AGENDA
JACKSON MUNICIPAL REGIONAL PLANNING COMMISSION
CITY HALL – GEORGE A. SMITH MEETING ROOM
FIRST FLOOR – 109 EAST MAIN STREET – SUITE 107
APRIL 7, 2021 – 3:00 P.M.

SITE PLAN STAFF REPORT

Jackson Storage

PRELIMINARY SITE PLAN		
SP-01

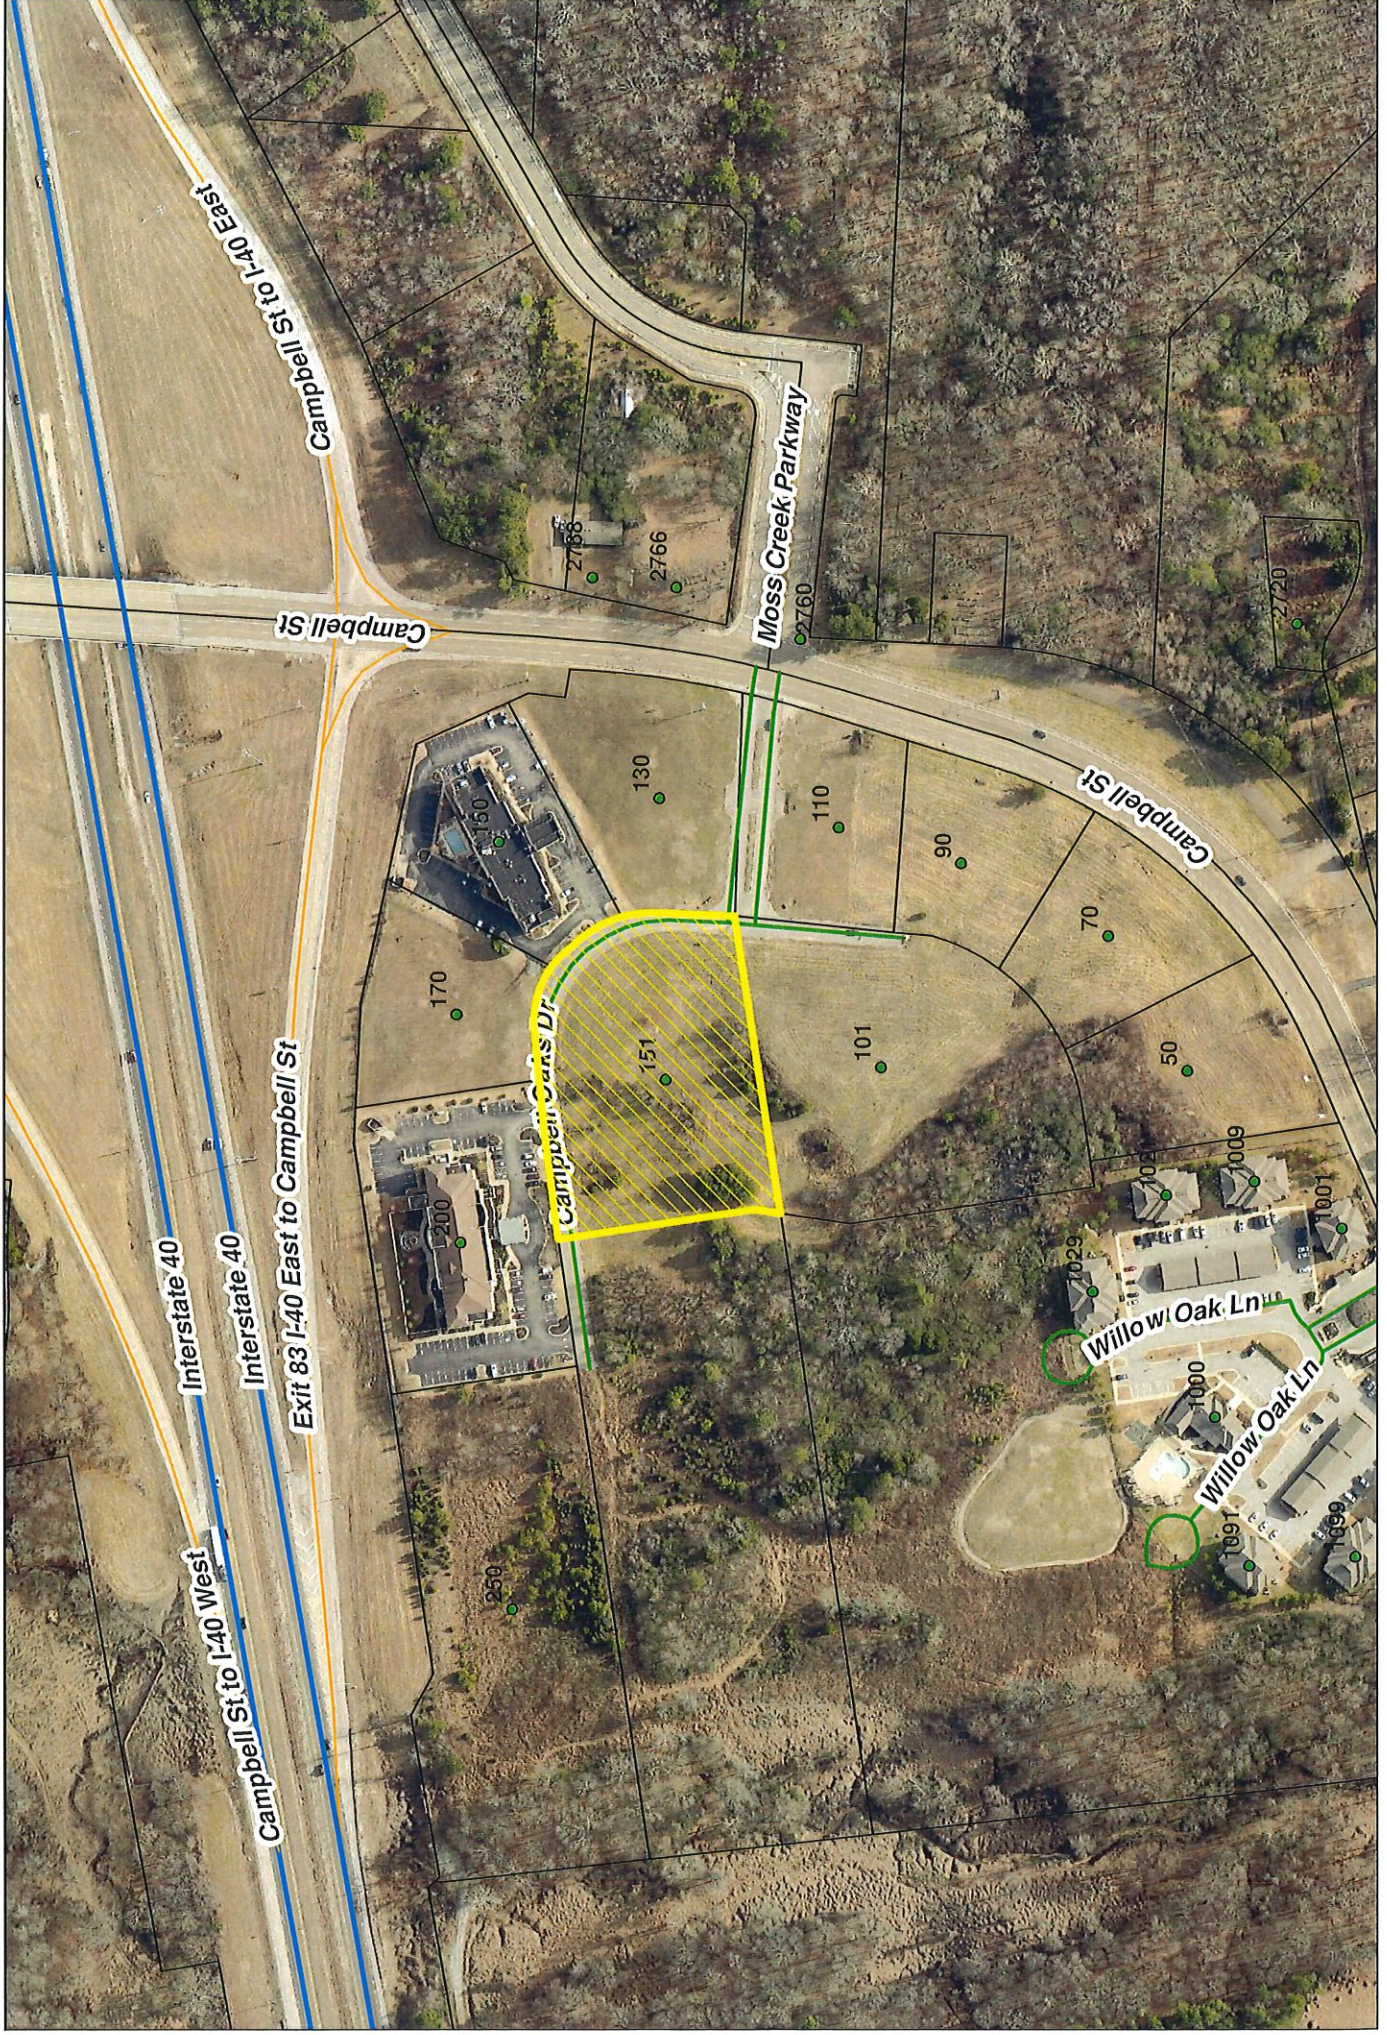
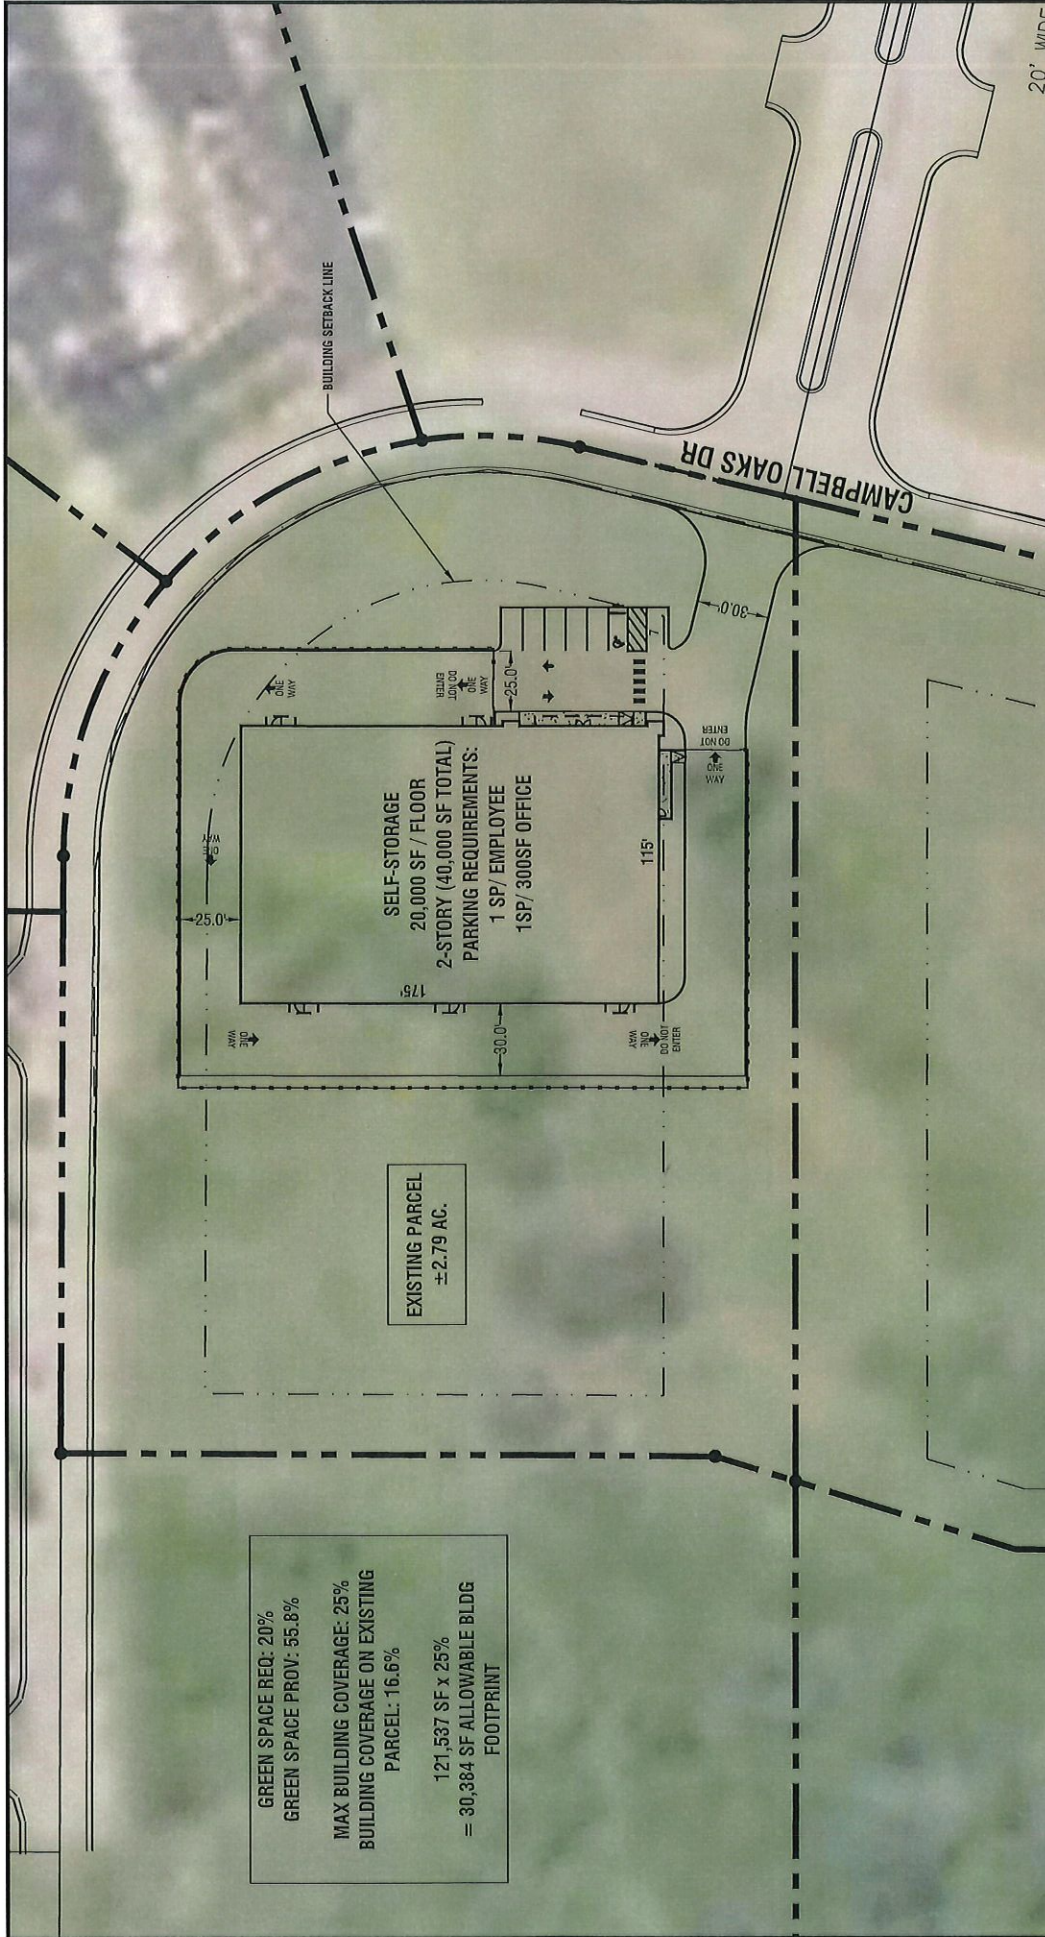
The site plan shows that there will be one (1) two-story building with a 20,000 sq. ft. footprint and a 40,000 sq. ft. interior space located on a 2.79-acre lot. There will be a total of two hundred sixty two (262) units. The buildings will comply with yard, lot coverage, and height requirements.

The preliminary site plan shows that proposed greenspace will meet the requirement of 20%. The plant schedule also meets the minimum requirements according to the Landscaping Ordinance for the City of Jackson.

The site plan shows that there will be 7 parking spaces. All parking spaces and aisle widths will comply with the Zoning Ordinance parking requirements.

The Engineering department will need a Stormwater Detention Analysis report for a 2, 5, and 10 year storm showing no-net increase in stormwater runoff for the site. The capacity of the area detention pond should be shown to control the volume of stormwater runoff from a 2-year, 5-year and a 10-year frequency 24-hour duration storm. Please include summary of findings in front section of the report and if pond capacity does or does not exceed a 100-year storm.

The staff recommends that the Planning Commission approve the site plan for Jackson Storage.
